# Resolution of the ongoing discussion on use of MMSE tap-weight optimization for TDECQ

Relative to Comments I-28 (Ghiasi), I-37 (Le Cheminant) against draft 3.0 802.3db

IEEE P802.3db 100 Gb/s, 200 Gb/s, and 400 Gb/s Short Reach Fiber Task Force

TF Ad Hoc Teleconference, April 28, 2022

# How is TDECQ performed today?

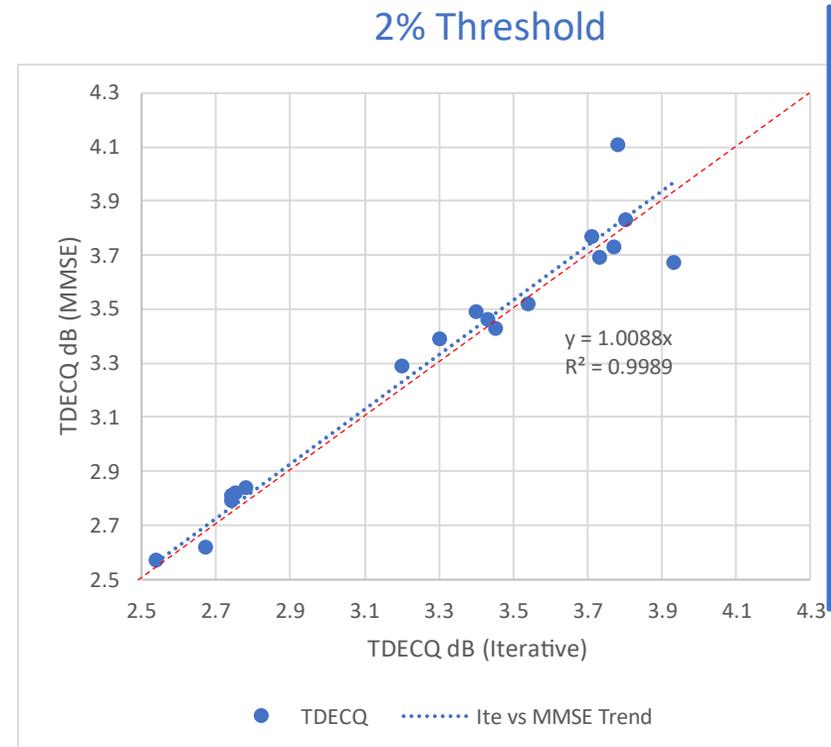
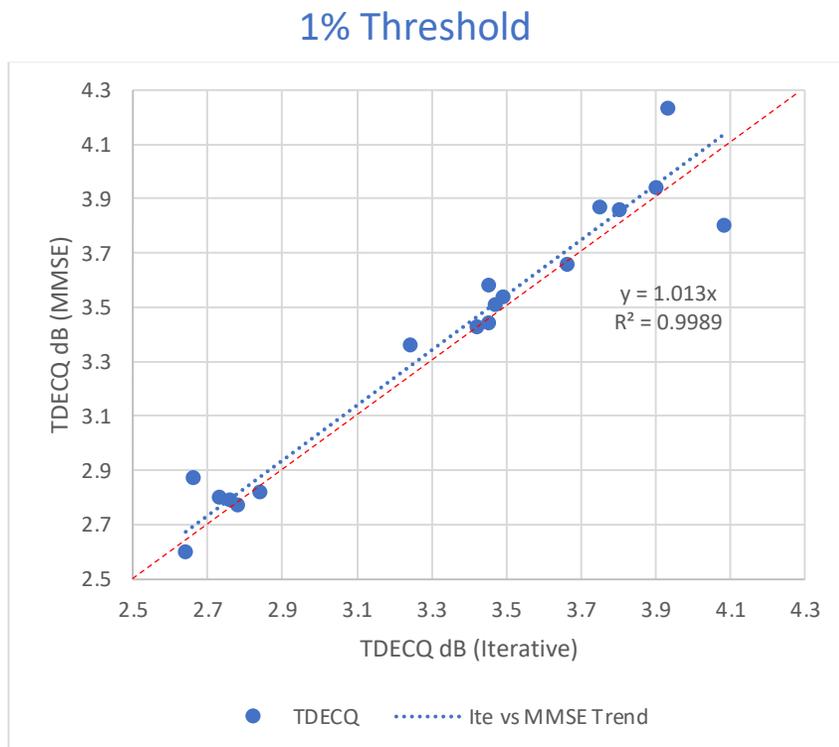
- T&M vendors I am familiar with provide a ‘full search’ to optimize EQ tap weights yielding the lowest observed TDECQ penalty. However, ‘full search’ is a secondary method (they default to faster optimization methods)
  - T&M 1: “Iterative Optimization” must be enabled to perform Clause 121 full search
  - T&M 2: “Extended search” must be enabled to perform Clause 121 full search
- Our opinion: Majority, perhaps 90% of TDECQ measurements made today are performed using something other than the full search allowed/defined by clause 121 to optimize EQ tap weights
